201 SPEAR STREET OFFICE BUILDING

FINAL Environmental Impact Report

FINAL ENVIRONMENTAL IMPACT REPORT

201 SPEAR STREET JOINT VENTURE 201 SPEAR STREET OFFICE BUILDING

Land Use Map

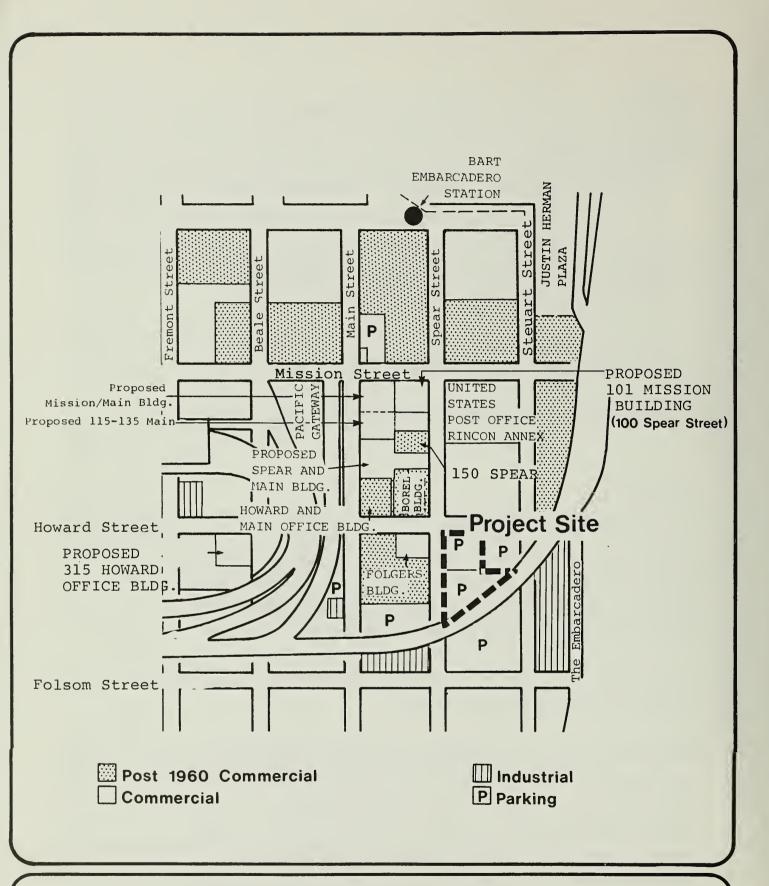
The parking/land use maps for the 135 Main and 201 Spear EIRs have been reviewed and corrections/revisions are noted as follows:

Figure 10 on page 18 of the 201 Spear EIR is revised to correct parking and industrial land use designations. Figure 18 also depicts a parking facility as the land use on the northeast corner of Mission and Main. This is private parking and has not been included in the survey of available public parking. The title of Figure B-1, page A-39 of the EIR is revised to read "Public Parking Survey" to clarify that the parking survey was conducted for facilities available to the public.

Figure No.29

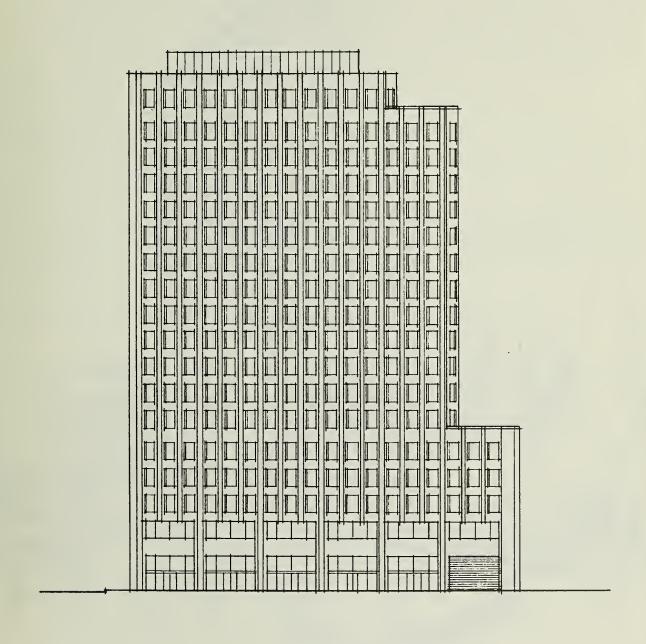
Two configurations that would not exceed bulk requirements and thus eliminate the need for Conditional Use authorization are described in the Initial Study (Appendix A, page A-5, Appendix figures 3,4), and in a new Alternative 6 (incorporated as a text change, page 129).

This alternative would bring the project into conformance with height and bulk requirements by shifting floor area from floors 6 and 7 to floors 16-18 (see Figures 29 and 30, pages 129b and 129c). This would reduce the maximum diagonal dimension above 70 feet to 180 feet, or 20 feet less than 200-foot maximum prescribed under 240-G Height and Bulk District regulations. The terrace at the 16th floor would be elevated to the 18th floor and the lower terrace would be at the sixth rather than the eighth floor level. The gross floor area of the building would not change, nor would the gross leasable area or the basement area. The height would not exceed the 240 feet allowed. The parking provided, delivery access and other building features would also remain unchanged.

Figure No.34

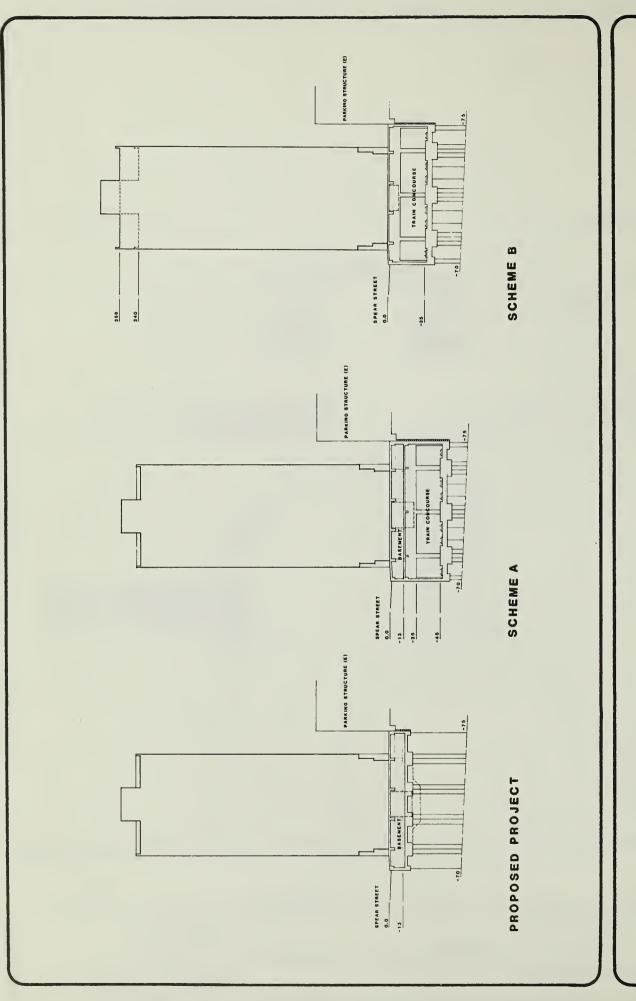
This alternative explores the possibilities for joint development of the 201 Spear Office Building site within the Rincon Annex commuter rail station relocation alternative. Figure 34, page 129i compares the Howard Street elevation of the proposed project with two schematic elevations (Schemes A and B) depicting the potential feasibility for joint development of the site. This alternative to the proposed project assumes, of course, that the Rincon Annex terminal alternative is chosen over the Transbay and 150 Harrison rail extension alternatives.

"In comparing the two schemes for this alternative, the project sponsor would prefer Scheme A because it would allow all the programmatic goals of the proposed project to be met. Since it would force the proposed rail terminal farther underground, the cost of that project would increase dramatically. Therefore, Scheme B was also developed. If Scheme B were to be selected, the project sponsor would request Conditional Use authorization for a PUD to allow greater building height, permitting mechanical and storage areas now planned for the basement to be included above ground without reducing the leasable area. In addition, the surface parking in Scheme B would cause the loss of much of the landscaped plaza in favor of a visually less attractive parking lot."
